Record of Decision
Village of Cuba
Municipal Waste Disposal Site
Town of Cuba, Allegany County
Site Number 9-02-012

DECLARATION STATEMENT - RECORD OF DECISION

Village of Cuba Municipal Waste Disposal Site Town of Cuba , Allegany County, New York Site No. 9-02-012

Cuba(V) Municipal Waste Disposal Site
 LIMIT OF CAP AND LOCATION OF PHYTOREMEDIATION SYSTEM

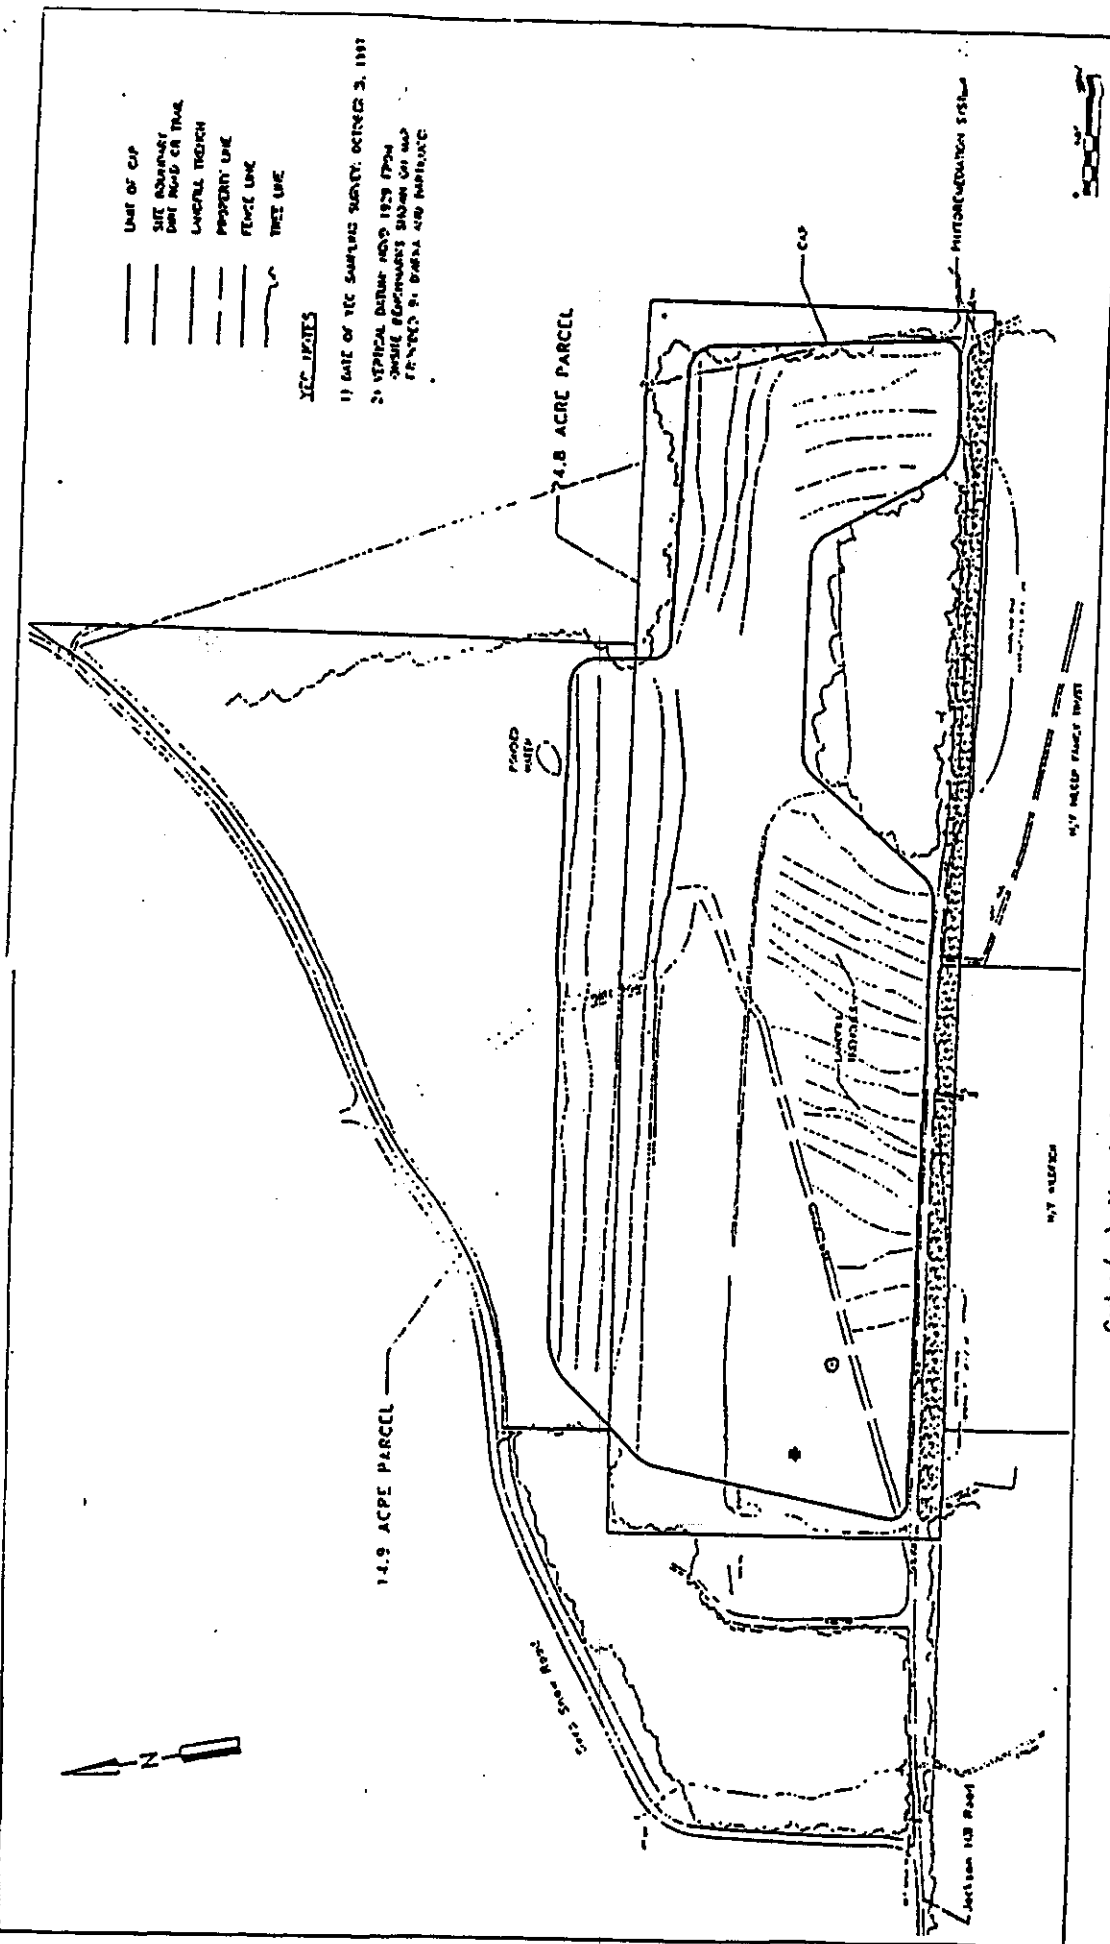
Comment 1. How many poplar trees are you going to plant?

Comment 12. Where will the water in the diversion ditch go? Will the ditches be able to handle the water during heavy runoff events?

Comment 15. Is it necessary to cap the whole site?

Response 1. As currently estimated, 2000 hybrid poplar trees will be planted in a one acre area (25' x 1600') at the south toe of the landfill.

Response 12. During design, an area wide surface water flow model will be used to design the diversion trench and to insure nearby streams east and west of the site are capable of receiving the flow. Erosion protection for the trench outlets will be incorporated as needed.

Response 15. Do to the nature of waste disposal in dug trenches it is necessary to cap the whole site. The Department evaluated waste consolidation during the FS. Consolidation was factored out due to the possible short-term impacts of excavating, handling waste and cost.
